UNITED STATES PATENT AND TRADEMARK OFFICE

APPLICATION NO.	FILING DATE	FIRST NAMED INVENTOR	ATTORNEY DOCKET NO.	CONFIRMATION NO.
10/607,643	06/26/2003	Jonathan Edwards	31957-8013US1	8735

Office Action Summary	Application No. 10/607,643	Applicant(s) EDWARDS ET AL.	
	Examiner Chapman E Jeanette	Art Unit 3635

Fig. 3

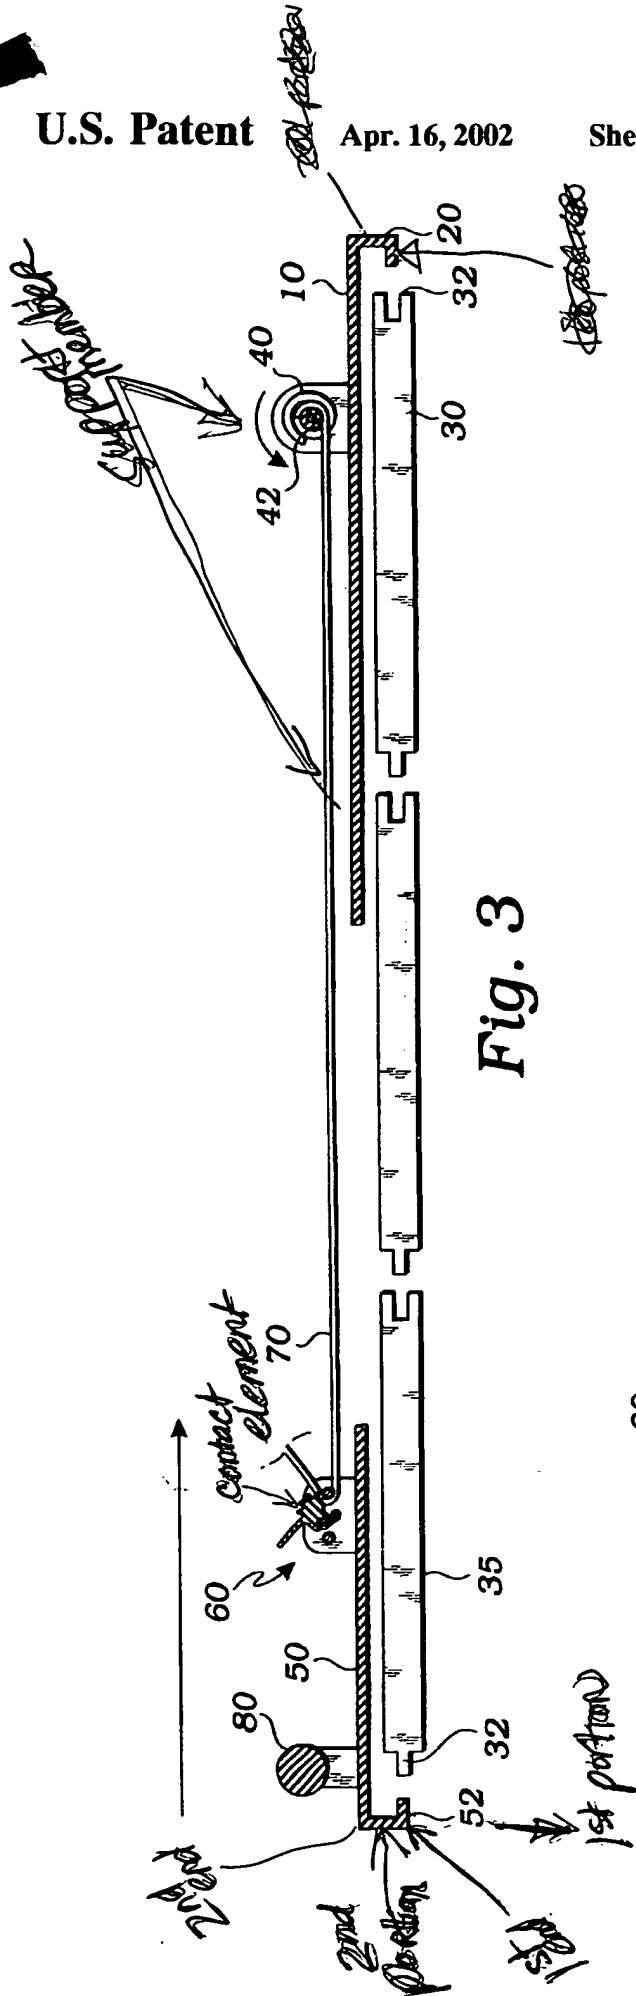
9. the engagement member includes a first portion 52 configured to contact a bottom surface of the first piece and a second portion, perpendicular to the first, to contact the back surface of the first piece 30; see figure 3; see annotations on patent copy; the second portion having a longitudinal axis transverse to the adjustment axis

10. The second portion of the engagement member has a first end coupled to the first portion and a second end opposite the first end; the distance between the first end and the support member is greater than the distance between the second end and the support member ; see figure 3 and annotations on patent copy

Fig. 4

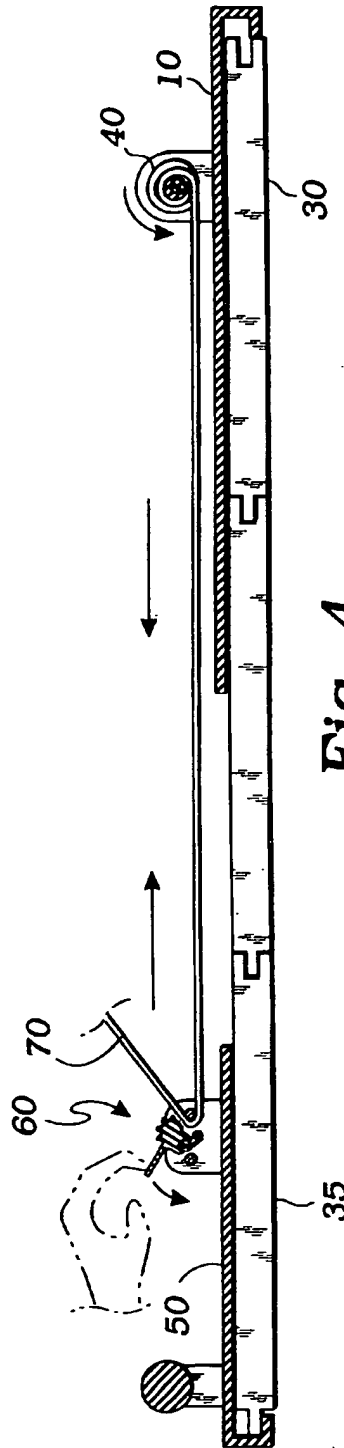
11. the securing assembly comprises a cam pivotably coupled to the support member 70 and a contact element at least proximate the cam; the cam is selectively pivotable in a first direction, shown in figure 4, to force the contact element against a front surface of the first piece to restrict movement of the support member relative to the first piece
